Addendum No. 1, June 4, 2026

Re: East Stadium Food Truck Park
Tennessee Technological University
TTU Project No. 26-075

SITE PLAN

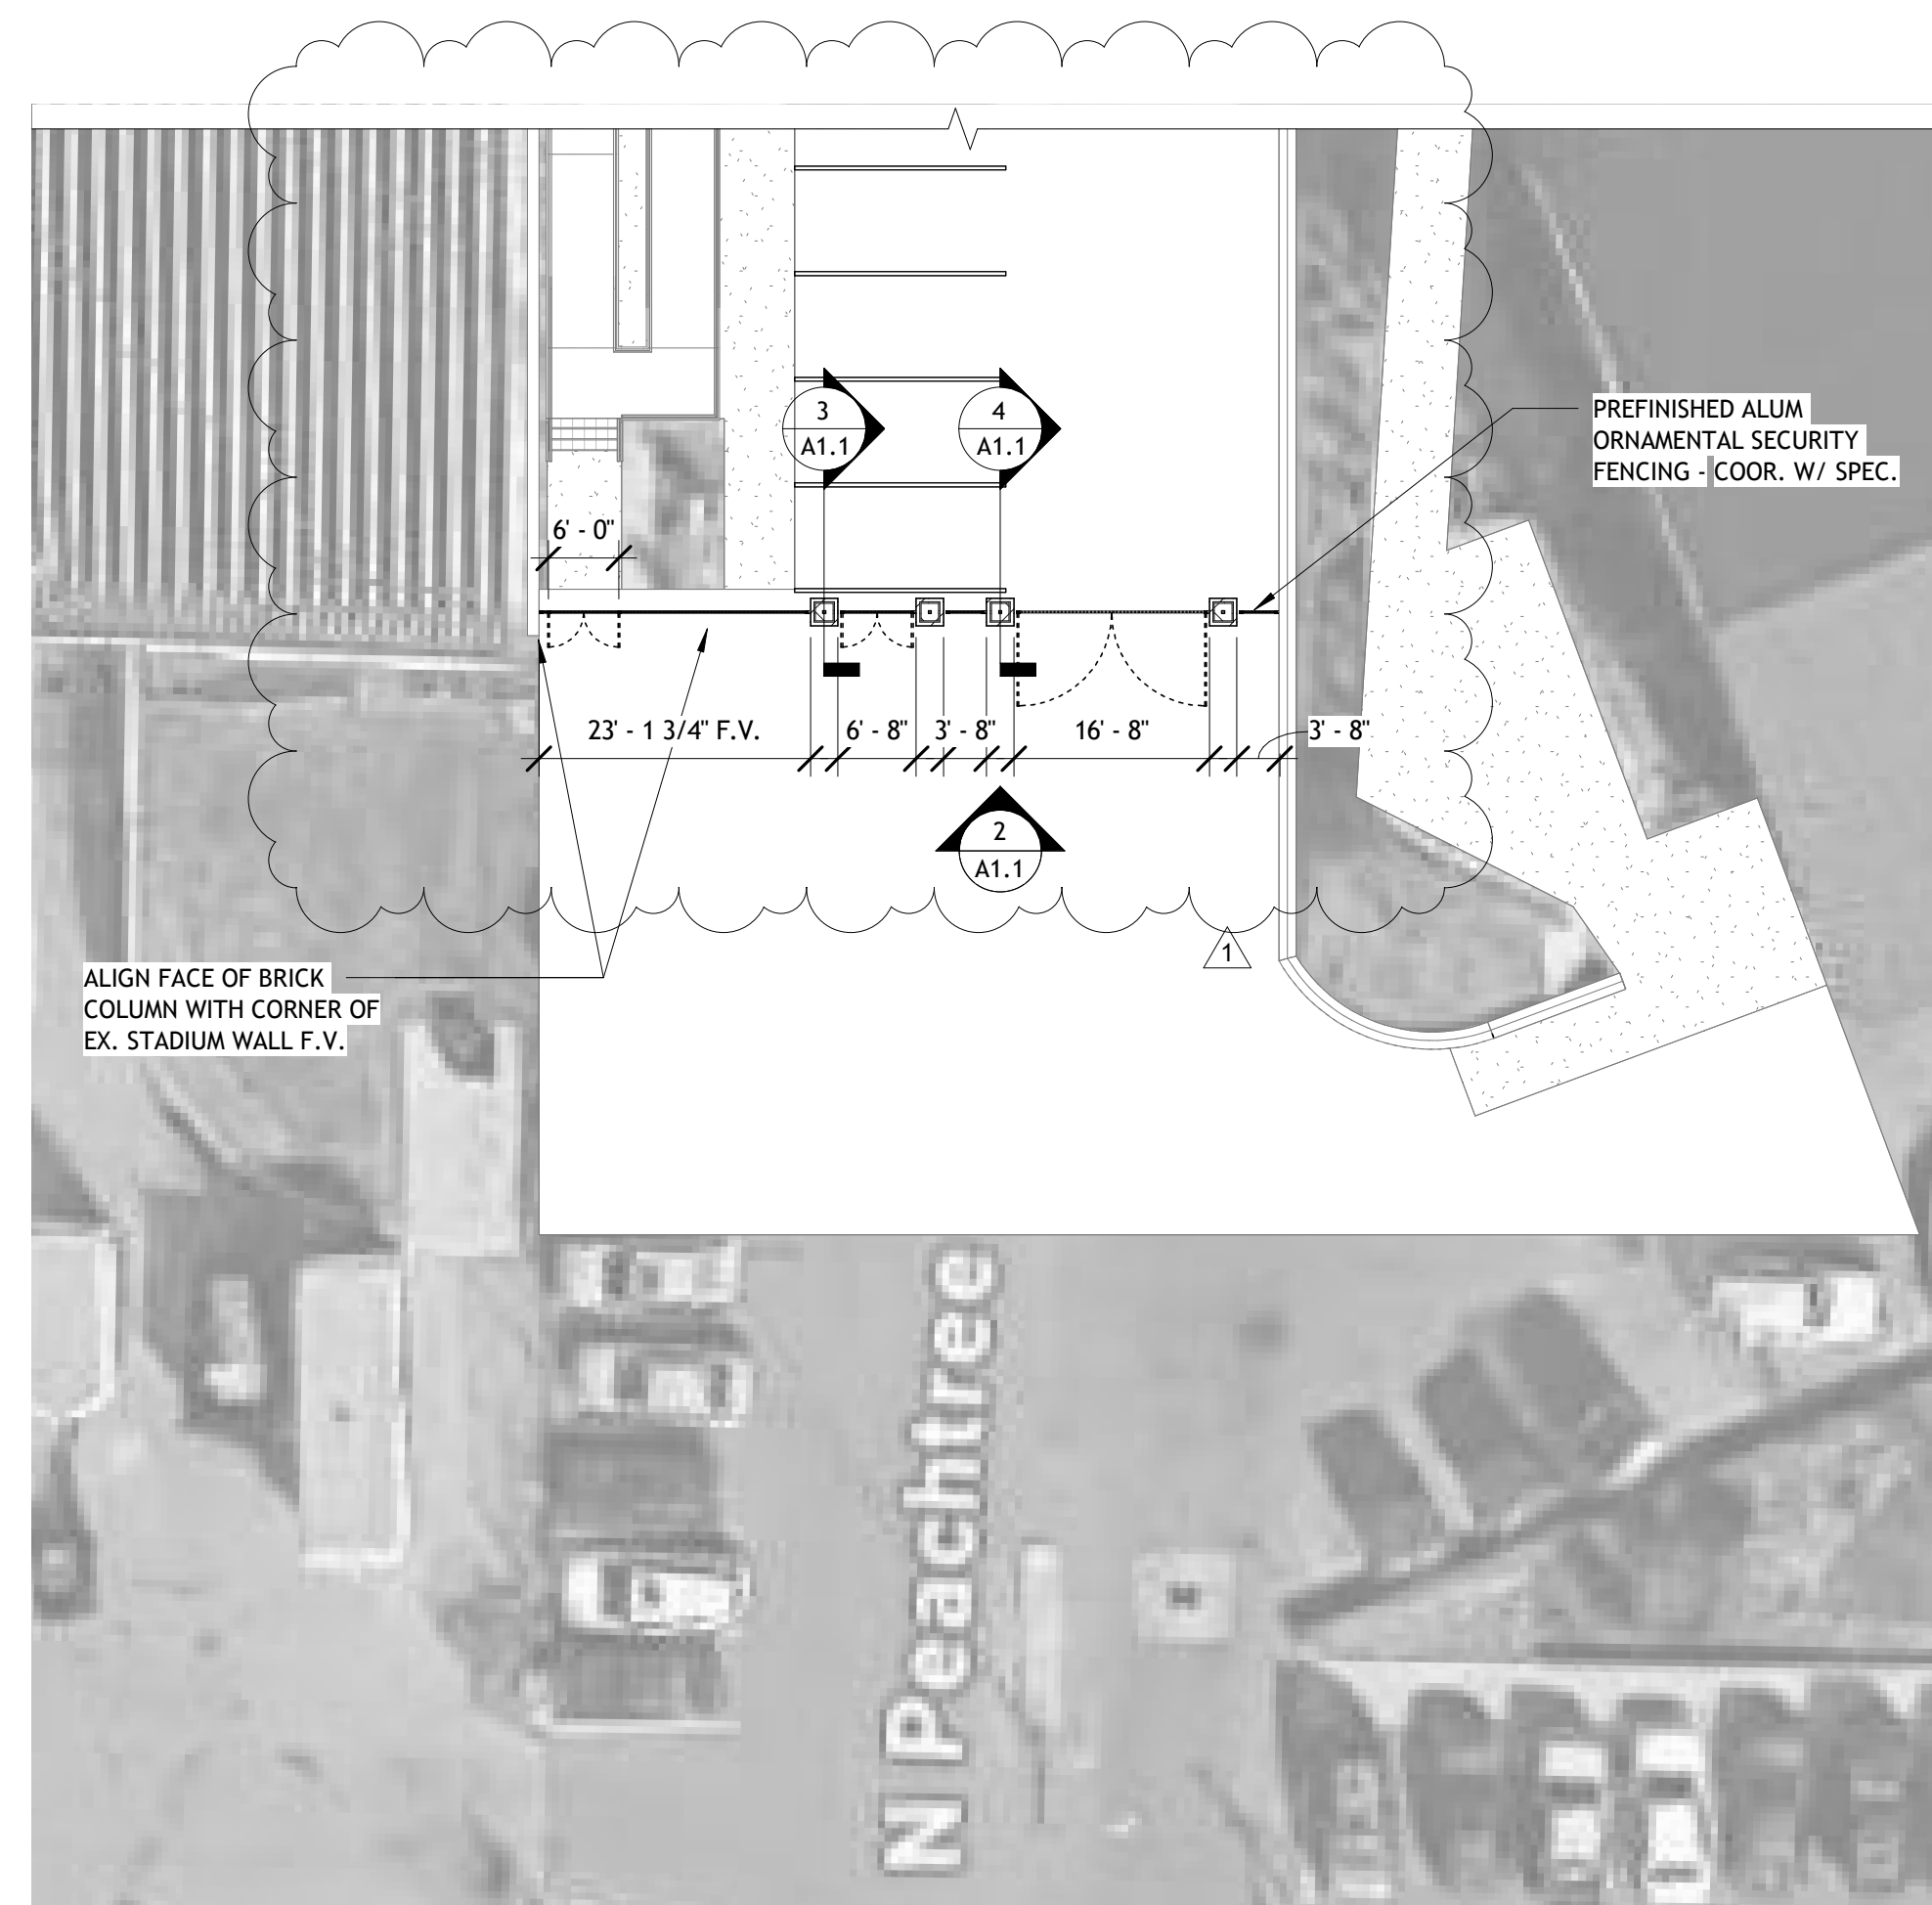
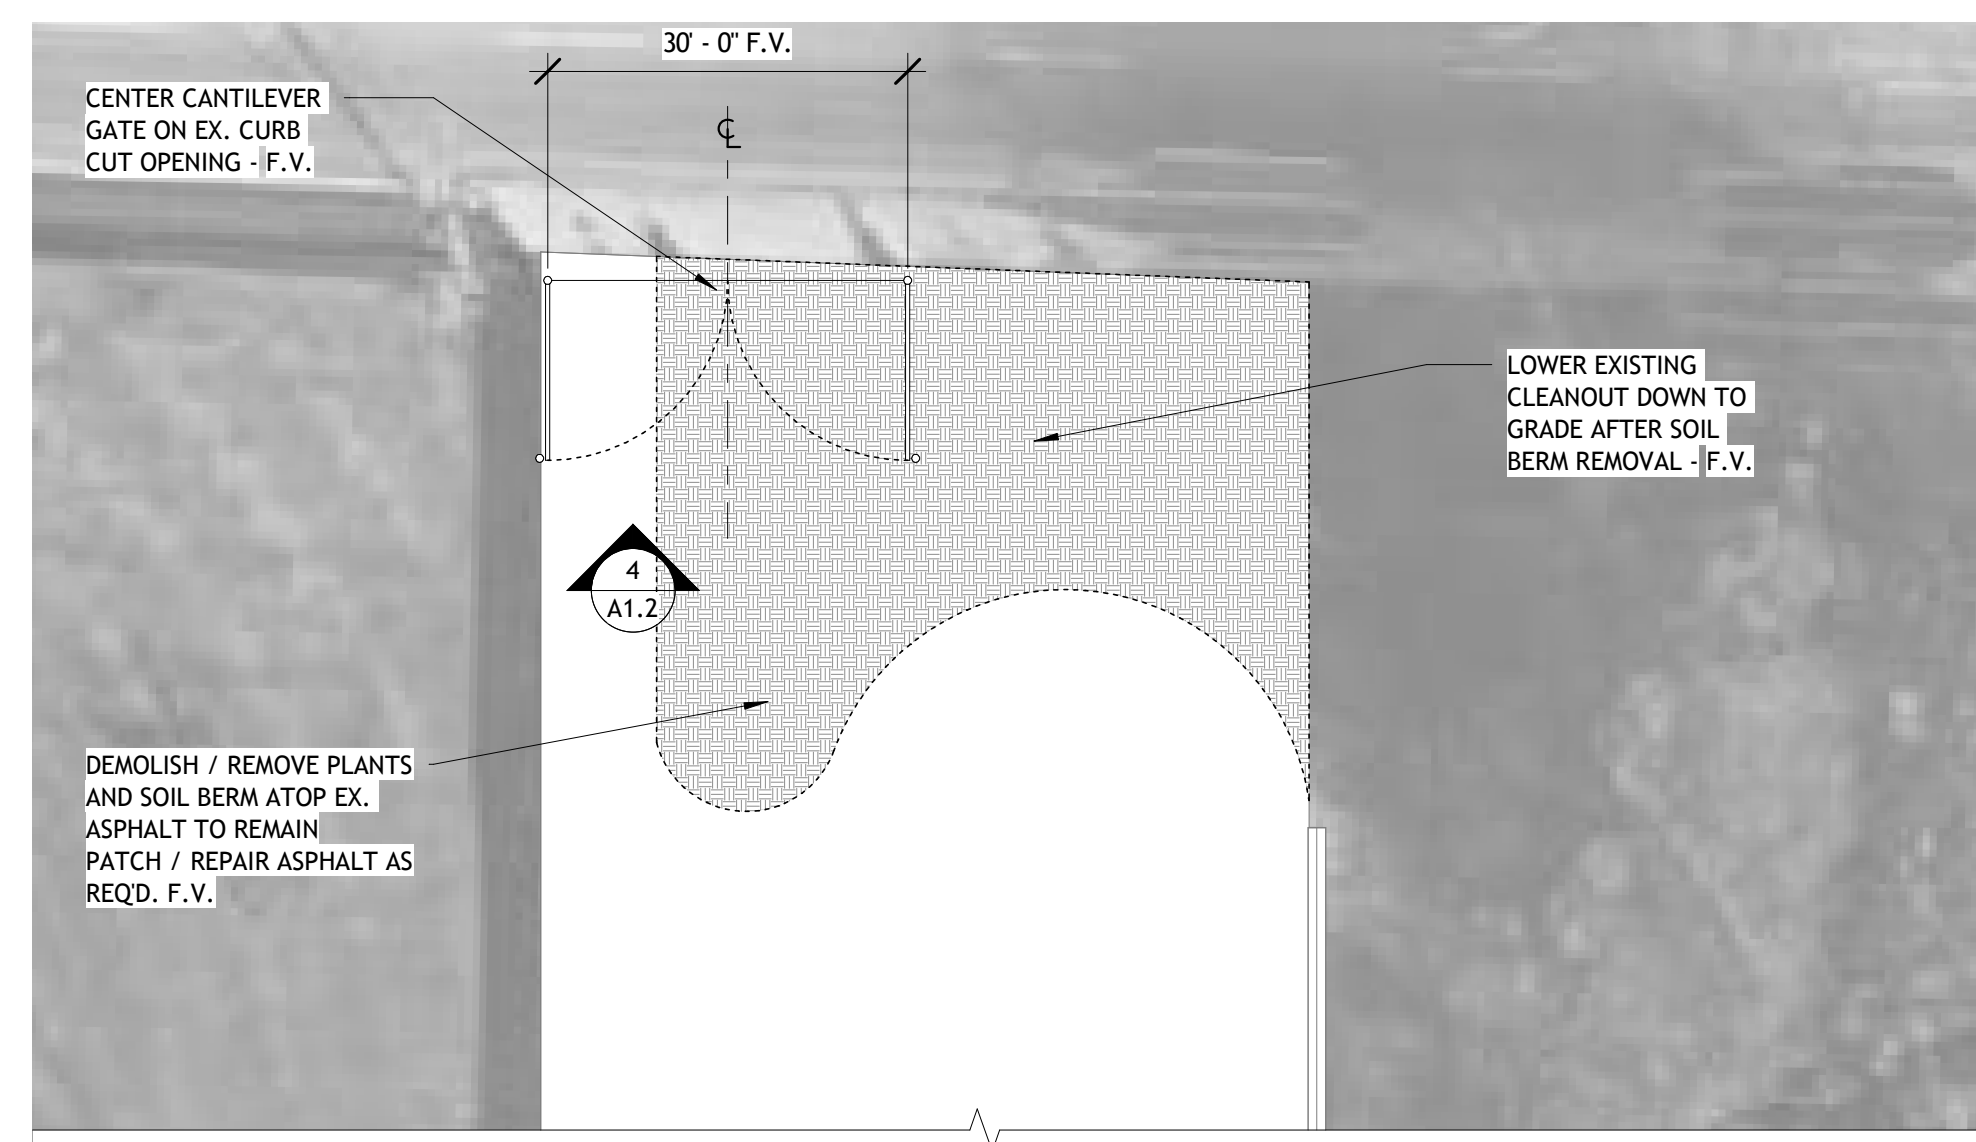
- 1) Refer to Drawings A1.1 & A1.2. Replace with attached Drawings A1.1 & A1.2, Revised Date 6/4/26. Changes reflect a revised layout for the entry gates.
